ADDENDUM NO. 1

Dam Maintenance & Concrete Spillway Repairs

Dimock Dam

Project No. Dimo26Wa

1 UNDER-DRAIN CLEAN-OUT DETAILS

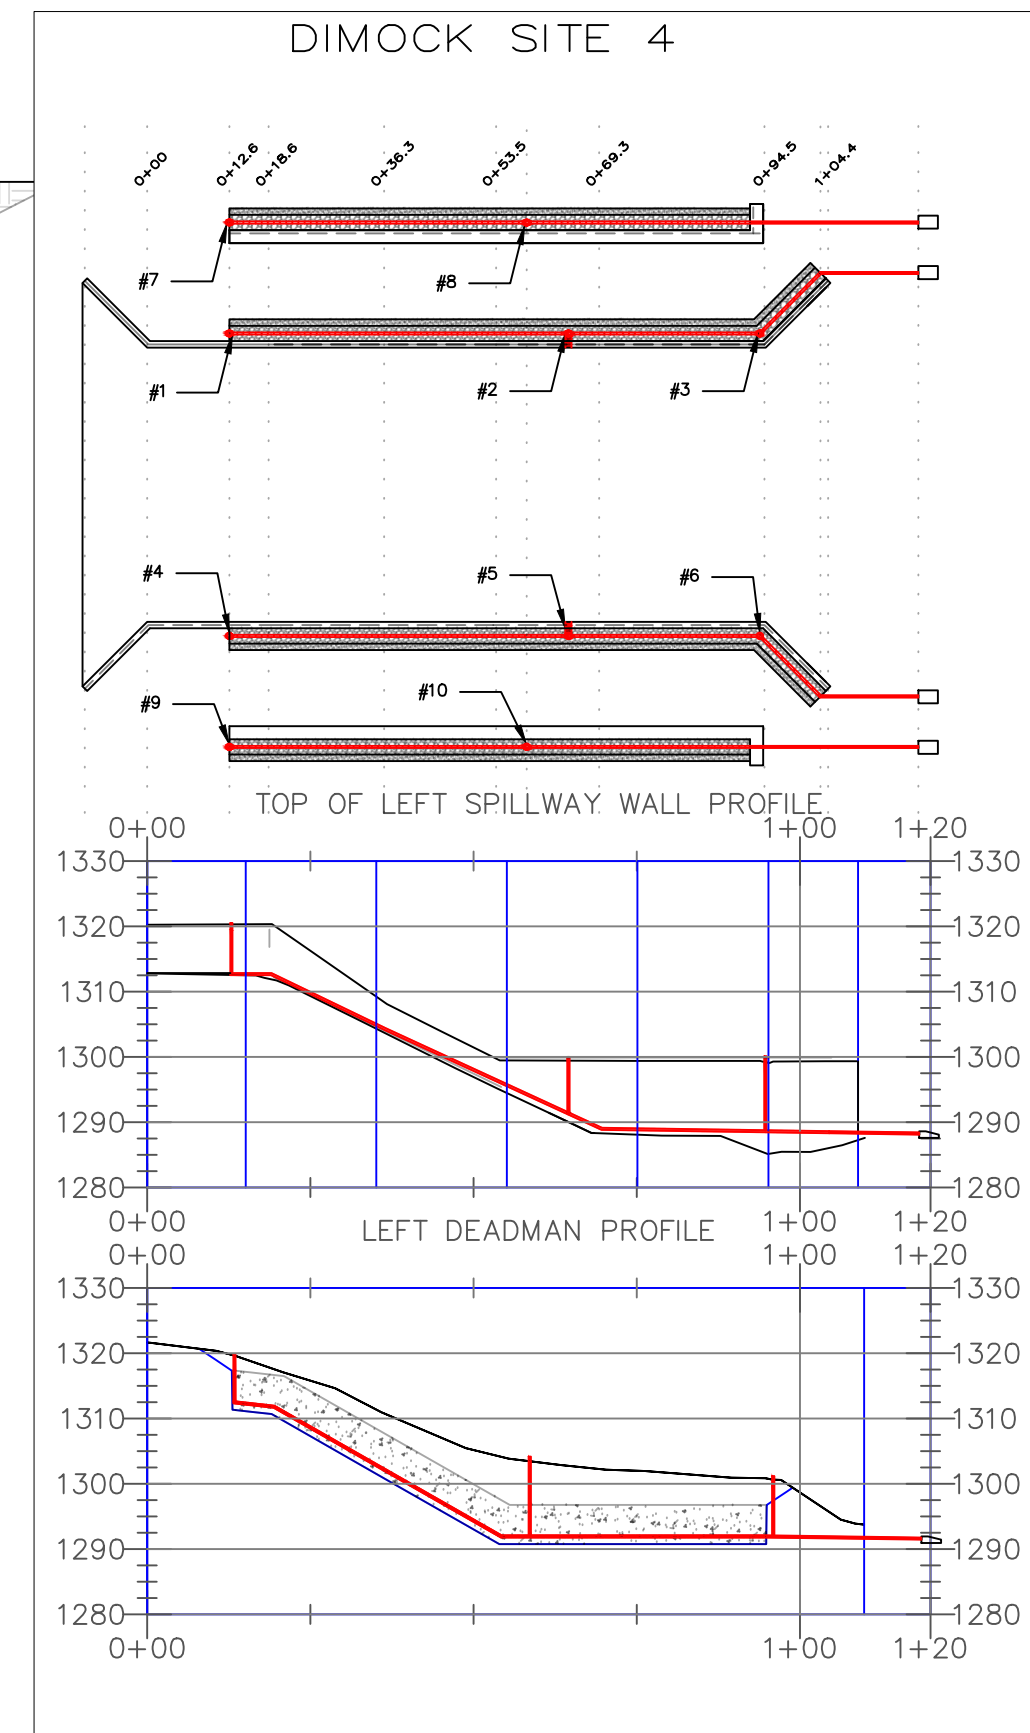
Item No. 1: Clean-Out Details

See attached detail drawings for the cleanout details.

** NOTE: ALL UPSTREAM CLEANOUTS SHOULD BE INSTALLED AT THE UPSTREAM LIMITS OF THE SLOTTED UNDERDRAIN TO INCORPORATE THE 90 DEGREE LONG SWEEP ELBOW. (ST 0+12.74)

** NOTE: WALL PENETRATIONS (CLEANOUTS #2 & #5) SHALL BE SEALED WITH GROUT OR OTHER APPROVED SEALANT.

** NOTE: ALL FITTINGS SHALL BE SOLID SCH 80 PVC
